VERIFICATION OF THE LUBRICATION SYSTEM AND REPLACEMENT OF THE OIL PRESSURE SPRING FOR ROTAX_® ENGINE TYPE 912 (SERIES) AND ROTAX_® ENGINE TYPE 914 (SERIES) SI-912-002

SI-912-002 SI-914-004

1.4) Subject

(fig. 2)

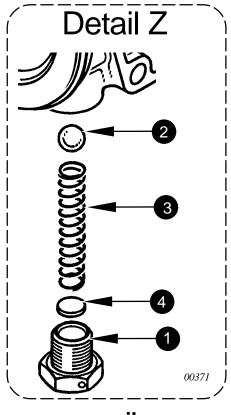
Remove plug screw (1) of pressure release valve (2) along with oil pressure spring (3), clean and inspect ball seat in the pump housing. A shim (4) is only fitted if it was necessary for achieving the correct oil pressure.

Fit ball 8,5 mm (2), new oil pressure spring part no. 838.122 (3) and plug screw (1) M12x1. Tighten plug screw to 25 Nm (220 in.lb) and safety-wire.
